**TSG-RAN Meeting #8
Düsseldorf, Germany, 21 – 23 June 2000**

RP-000212

Title: Agreed CRs to TS 25.142

Source: TSG-RAN WG4

Annex A (normative): Measurement Channels

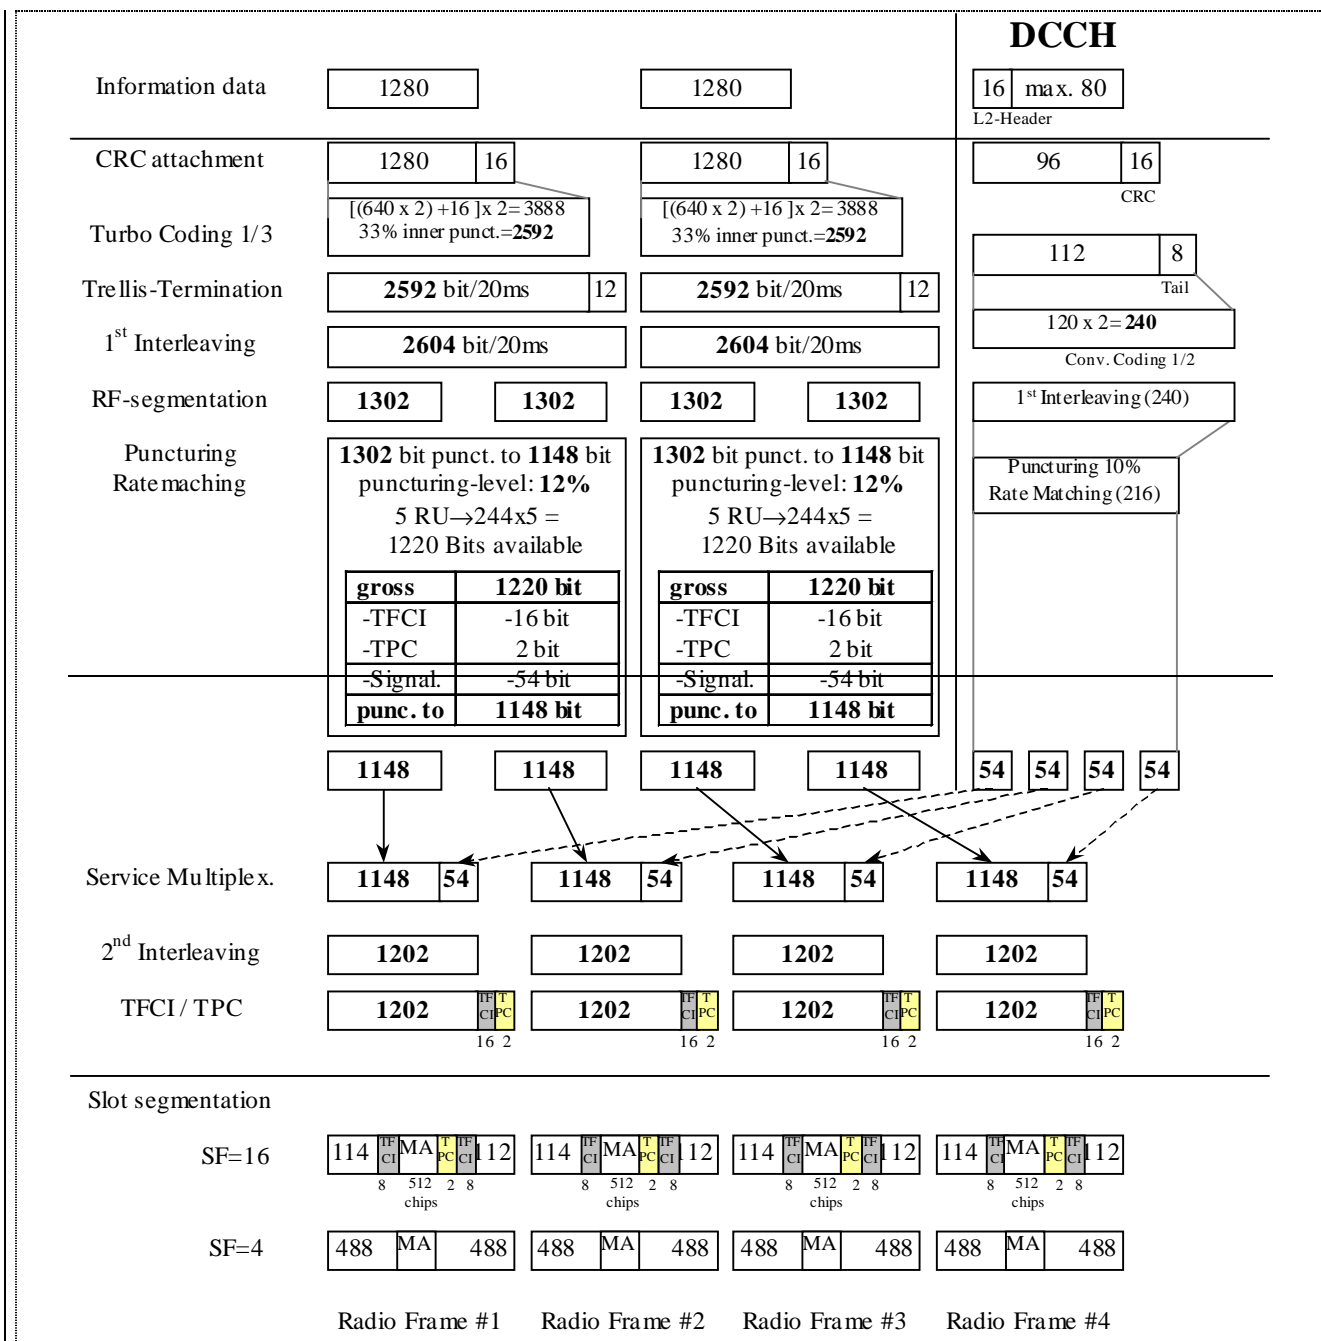
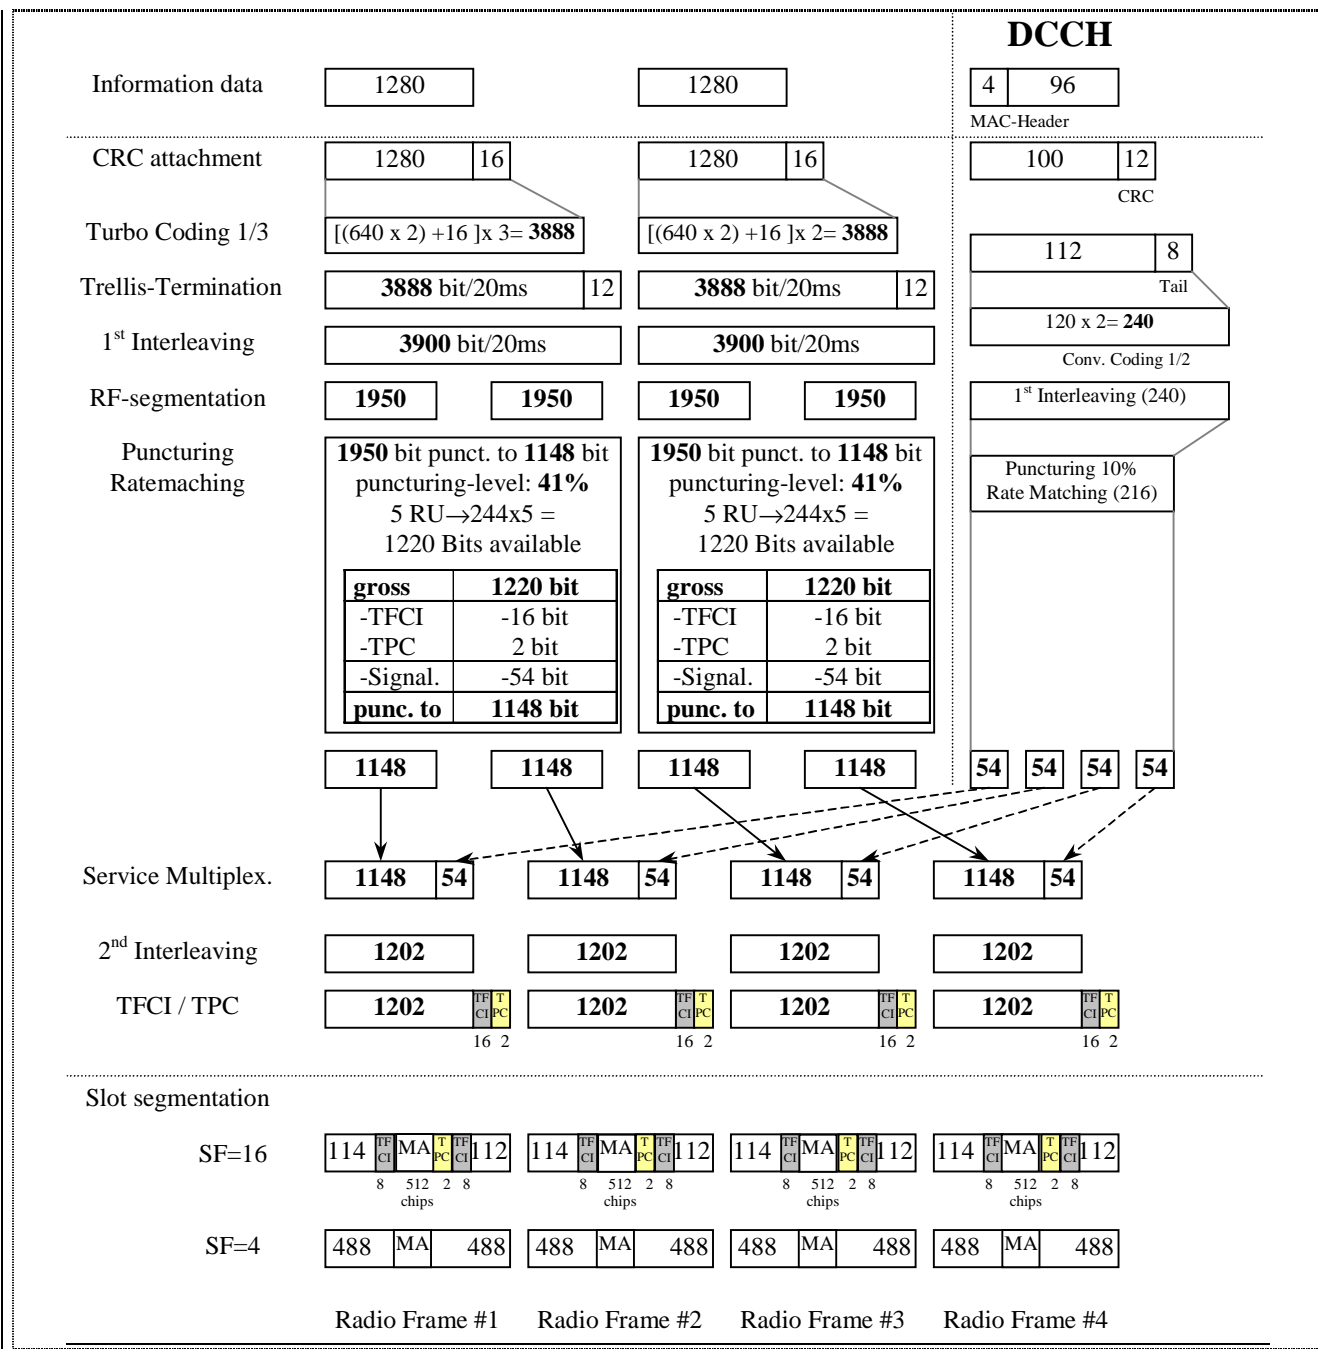
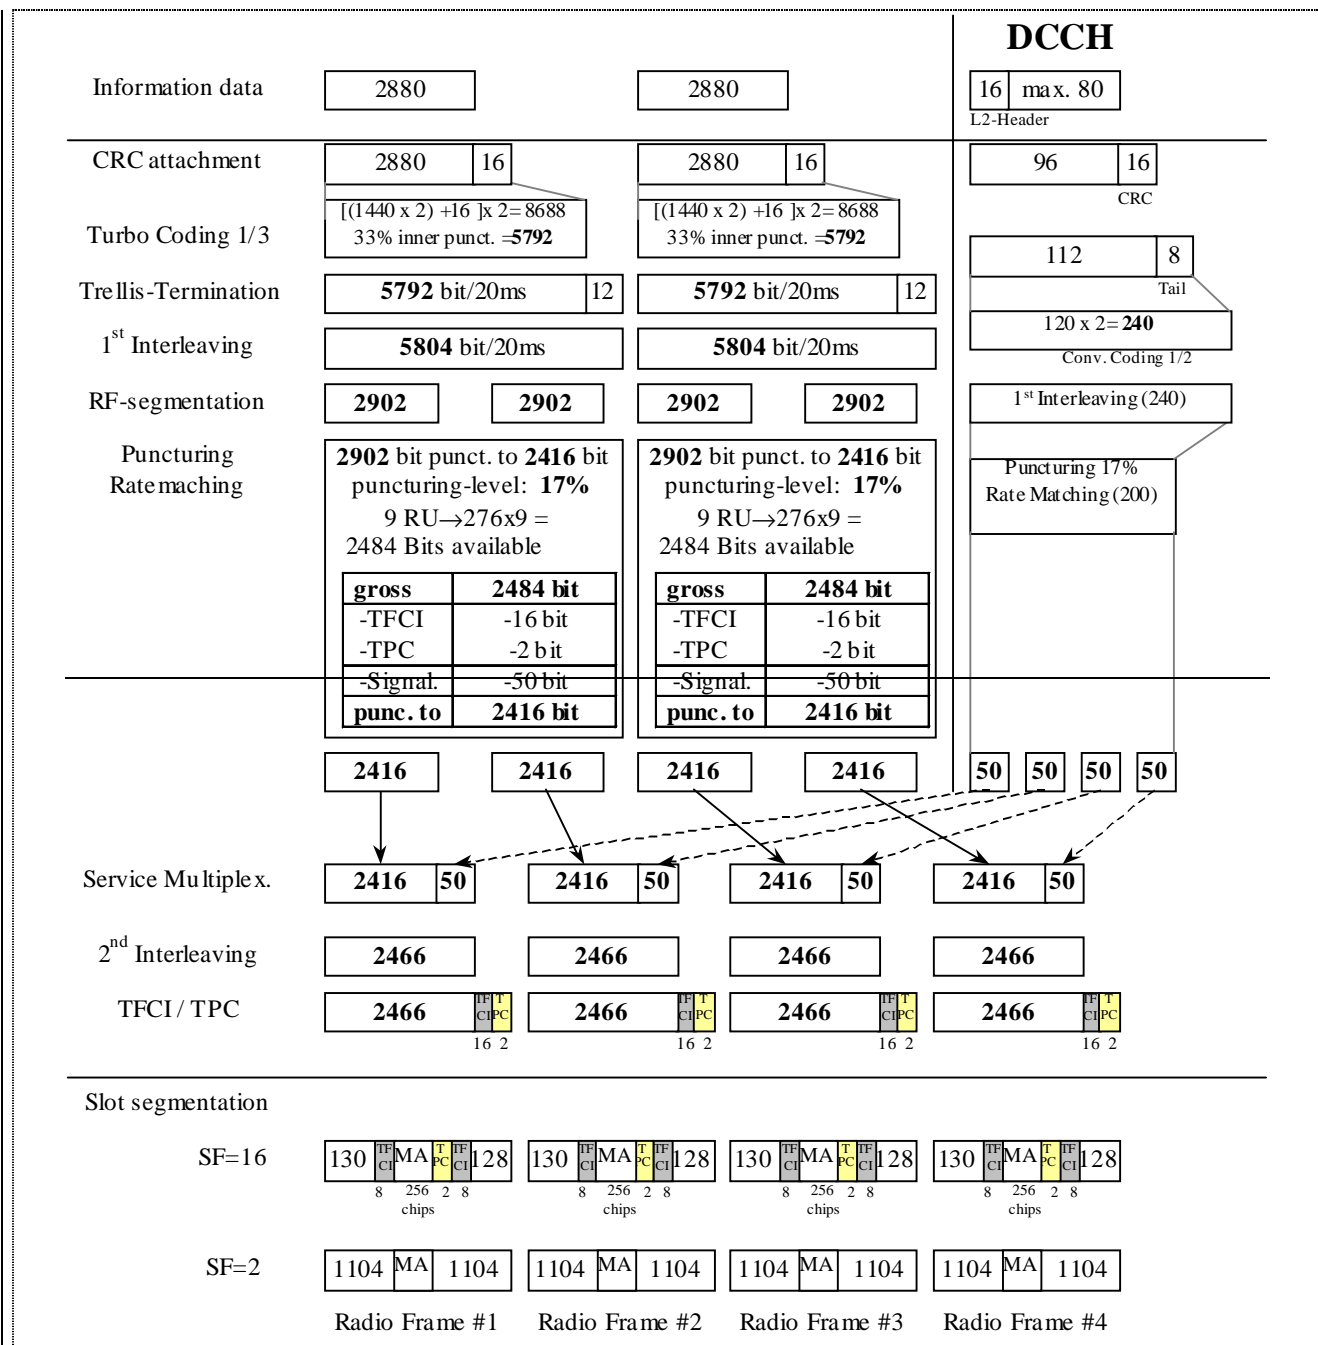
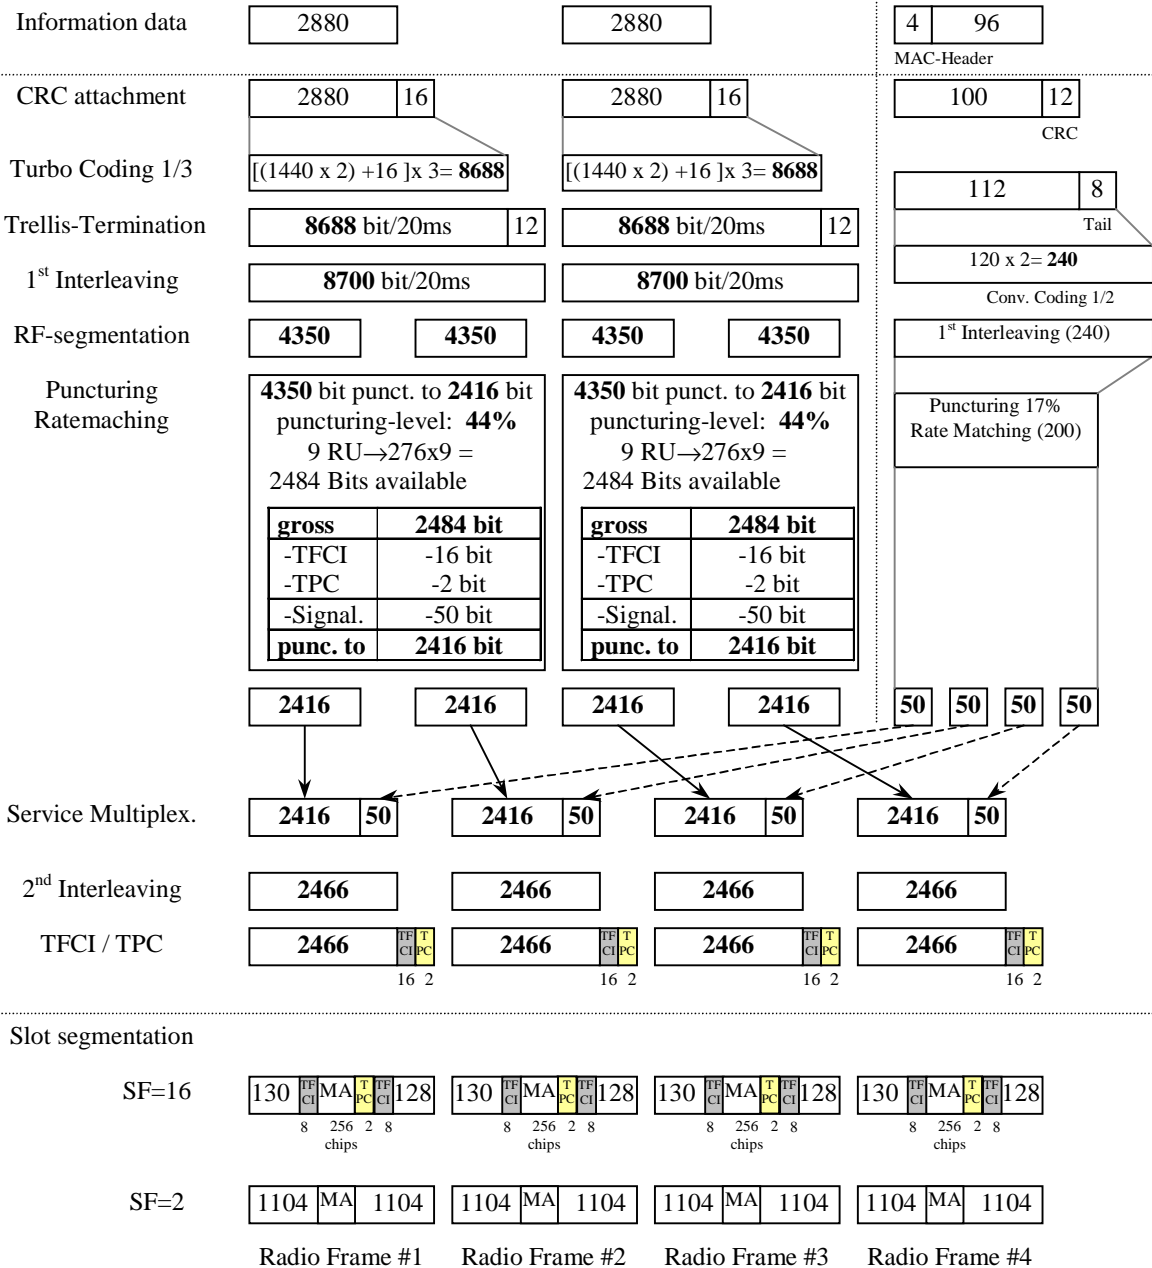
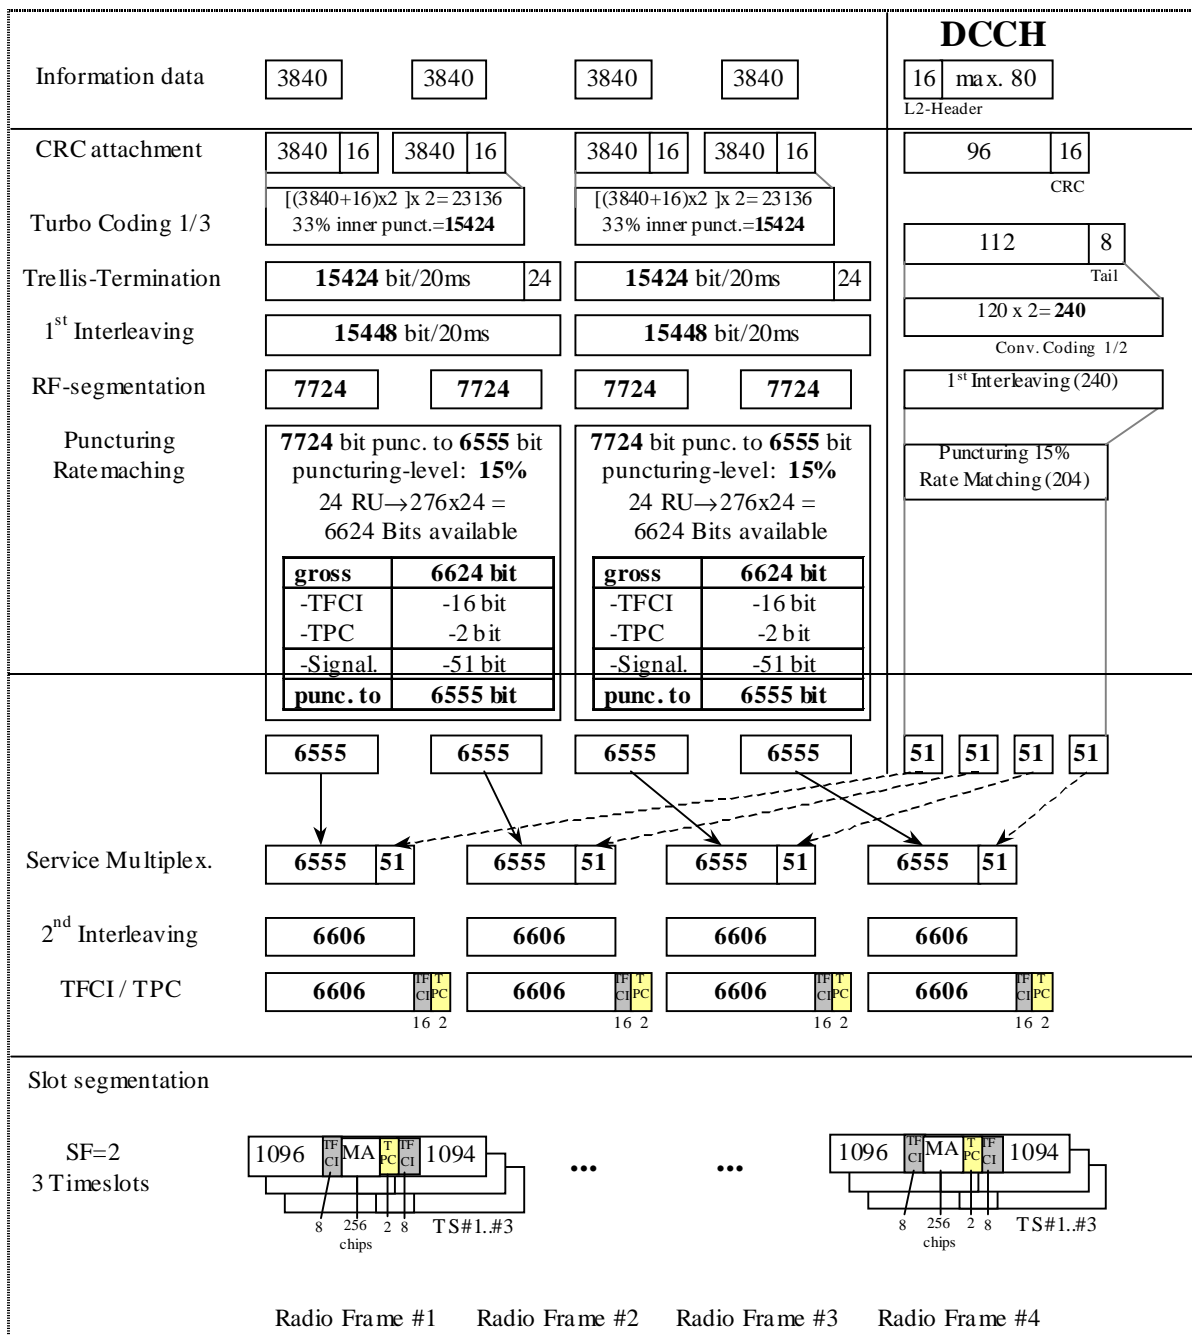
Alignment of the UL reference measurement channels with current RAN WG1 and WG2 specifications

Parameter	
Information data rate	12.2 kbps
RU's allocated	2 RU
Midamble	512 chips
Interleaving	20 ms
Power control	2 Bit/user
TFCI	16 Bit/user
Inband signalling DCCH	2 kbps
Puncturing level at Code rate 1/3 : DCH / DCCH	5% / 0%

Parameter	
Information data rate	64 kbps
RU's allocated	1 SF4 + 1 SF16 = 5RU
Midamble	512 chips
Interleaving	20 ms
Power control	2 Bit/user
TFCI	16 Bit/user
Inband signalling DCCH	2 kbps
Puncturing level at Code rate : 1/3 DCH / 1/2 DCCH	41.2% / 10%

Parameter	
Information data rate	144 kbps
RU's allocated	1 SF2 + 1 SF16 = 9RU
Midamble	256 chips
Interleaving	20 ms
Power control	2 Bit/user
TFCI	16 Bit/user
Inband signalling DCCH	2 kbps
Puncturing level at Code rate : 1/3 DCH / 1/2 DCCH	44.4% / 16.6%

Parameter	
Information data rate	384 kbps
RU's allocated	$8 \cdot 3TS = 24RU$
Midamble	256 chips
Interleaving	20 ms
Power control	2 Bit/user
TFCI	16 Bit/user
Inband signalling DCCH	2 kbps
Puncturing level at Code rate : 1/3 DCH / 1/2 DCCH	43.4% / 15.3%
